Technical Advisory Note

Quality Information										
Project:	Gurner Avenue, Austral – DA-1295/2021									
Project Number: SCT_00269										
Document Name:	Response to RFI from Council dated 9 November 2022 - Traffic									
Date:	9 November 2022									
Prepared:	Shawn Cen, Senior Consultant									
Reviewed:	Andy Yung, Director									
Authorised:	Andy Yung, Director

This technical memo responds to items 14 and 15 in RFI dated 9 November 2022.

RESPONSE TO SUBMISSION:

Figure 1 Proposed intersection layout

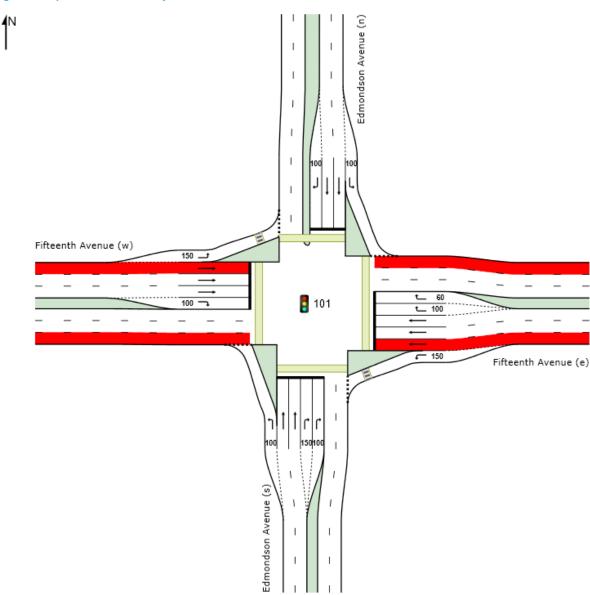
It is unclear as to which intersections have been assessed. TfNSW requires SIDRA modelling to show predicted growth with general practice usually showing modelling for the day of opening plus 10 years post-development. TfNSW requests the intersection of Edmondson Avenue and Fifteenth Avenue to be assessed in the SIDRA modelling. SIDRA outputs shall be submitted for further review.

It is noted that the intersection of Edmondson and Avenue Fifteenth Avenue is expected to be upgraded to a fully signalised intersection to accommodate the traffic increase in the future. The proposed geometry is based on the layouts specified in the *Austral and Leppington North Precinct Plan – Post Exhibition Planning Report* (Addendum) 2012 (**Figure 1**).

It is acknowledged that there is a minor difference between Traffix's original model and the duplicated model such that the duplicated model is fit for testing updated traffic demand. The SIDRA modelling with the addition of the subdivision traffic confirms that:

- There is a minimal increase in the throughput at the intersection (up to five percent increase in the AM peak hour in 2026 and 2036 associated with the residential subdivision).

- The intersection remains to operate at the same Level of Service after adding the development traffic. There is no change in Degree of Saturation and there is limited increase in intersection delays.

- Longer queue lengths occur for the western approach. However, the increment is minor and insignificant.
- By 2036, the intersection records a LoS F. As stated in Traffix's traffic study, it is noted that the intersection had already failed without the school development. Further infrastructure upgrade is necessary to accommodate the background growth, which is to be considered by TfNSW.
